BendPak Technical Service Bulletin

PL-6000DC - Wiring the 5585152 Power Unit

BendPak TSB 105-122022

Connecting the Power Unit P/N: 5585152

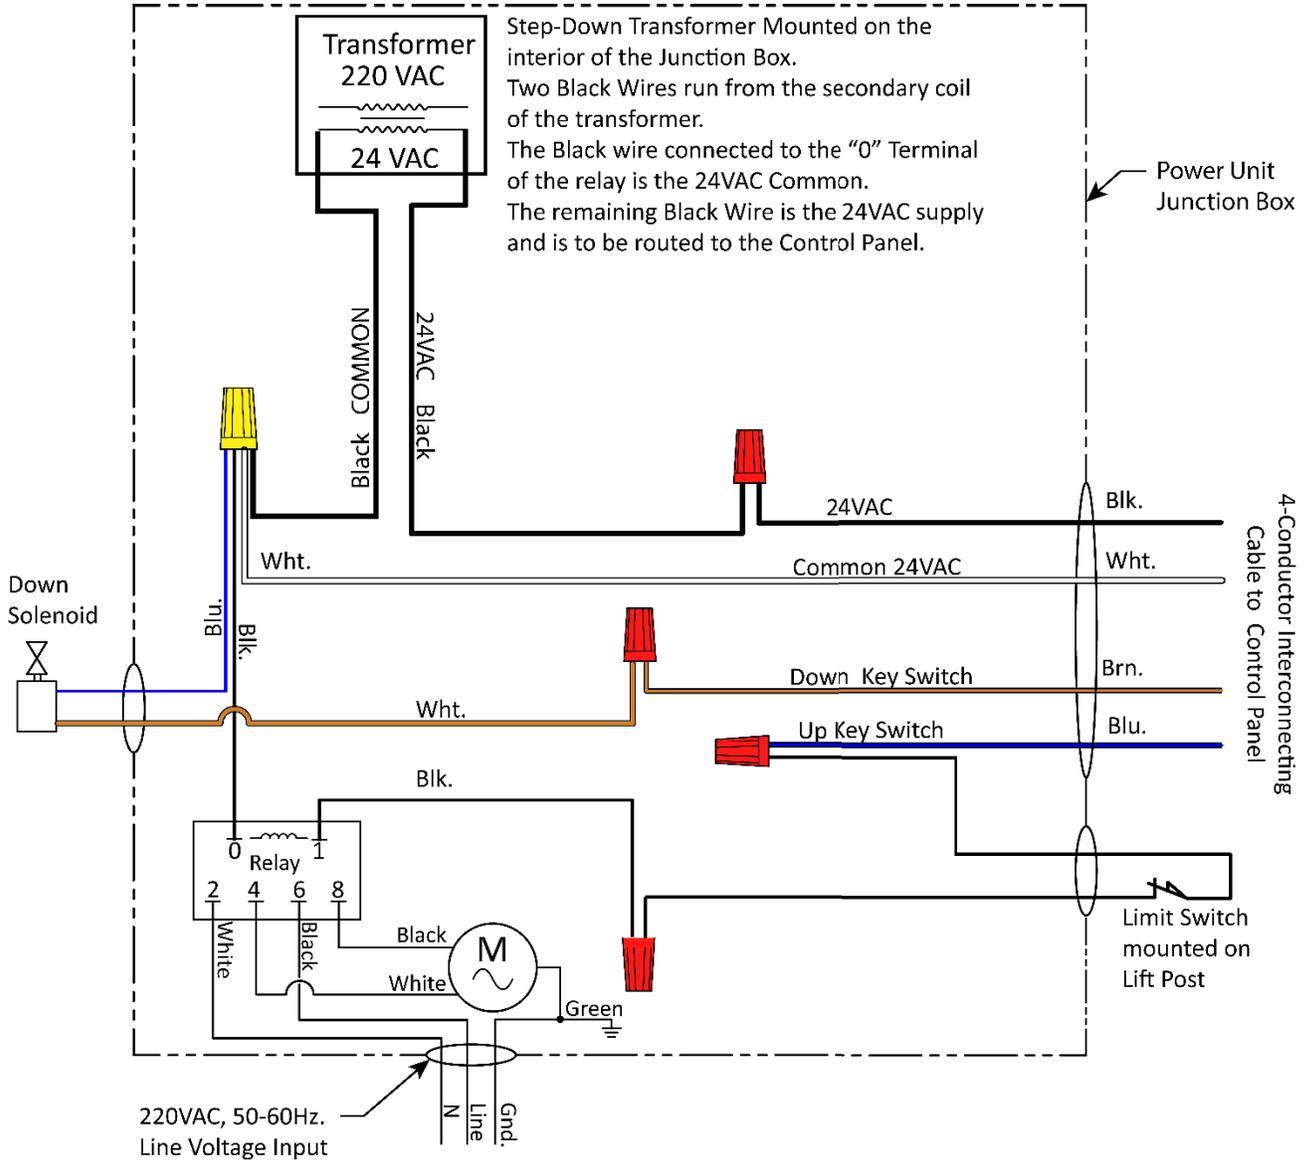
Verify the Power Unit part number. The label identifying the Power Unit is located on the motor housing. This Power Unit is provided with a Pigtail for the 220 VAC, 60Hz power input, the Controls input and the bottom right Pigtail. See Figure below.

Control Panel Wiring

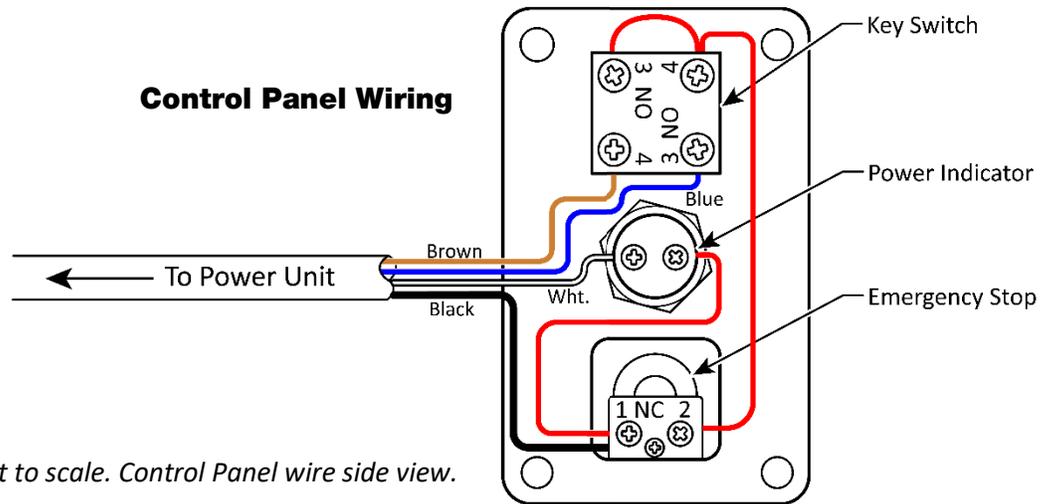
The purpose of this Technical Service Bulletin is to describe a change in the four-conductor interconnecting cable colors on the PL-6000DC Lift. The internal electrical connections in the 5585152 Power Unit and Lift Control Panel are detailed in a revised Schematic and Control Panel Wiring Diagrams. The Installation manual will be updated with the corrected schematic and wiring diagrams.

Drawing not to scale. Control Panel wire side view.
